MARION GENERAL HOSPITAL

Also, we would like to modify the current Hot Lab at the 441 North Wabash Avenue address of use. Specifically, we would like to make the current Hot Lab into two rooms, one to continue to be utilized as a Hot Lab, the other to be a non-restricted room. A diagram of the proposed setup is enclosed, titled Attachment 9.1. In addition, a close-out survey of the portion of the Hot Lab that is to be non-restricted is enclosed.

Close-out survey of part of the Hot Lab at 441 North Wabash Avenue

Close out map

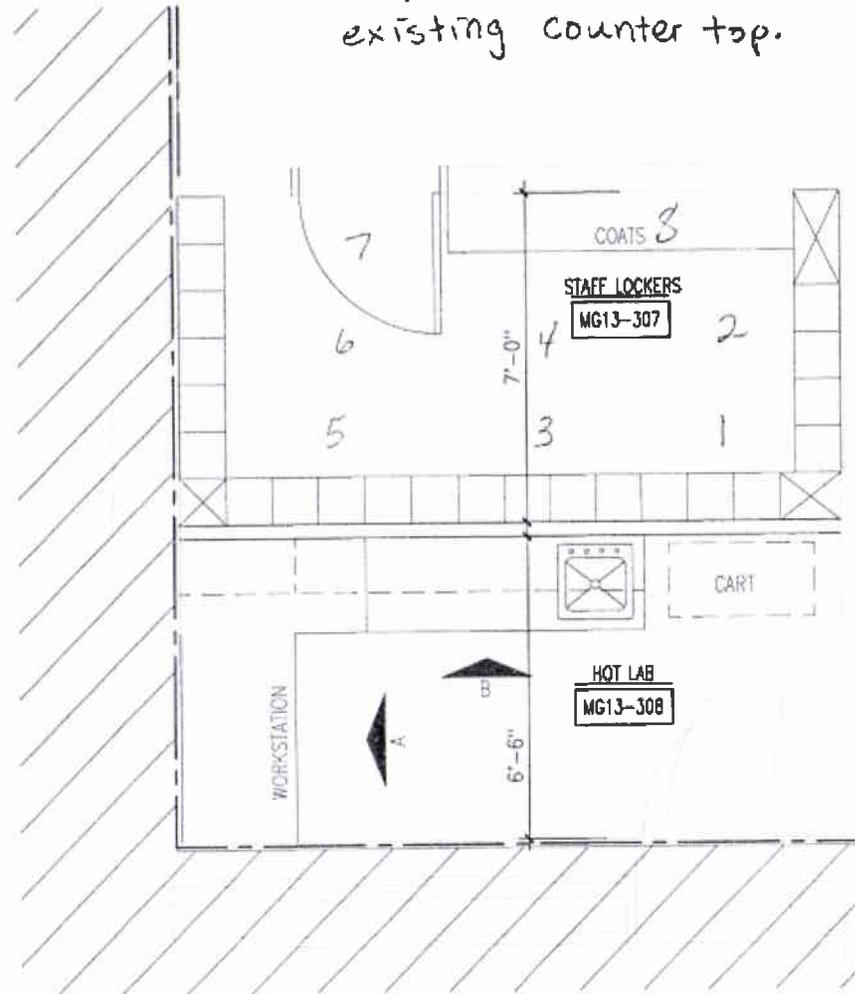
- * Numbers refer to locations of wipe samples
- * Wipes 7 and 8 were taken on an existing counter top.

Maximum removable contamination occurred in area 7. Gross count rate = 492 cpm/100cm². Net count rate (gross minus background) = 492 – 285 = 207 cpm/100cm². Net removable disintegrations per minute = 207 cpm/100cm² x 1.17 dpm/cpm = 242.2 dpm/100cm².

As of 12/10/08, all radioactive materials have been removed from the area of use and no removable contamination is present.
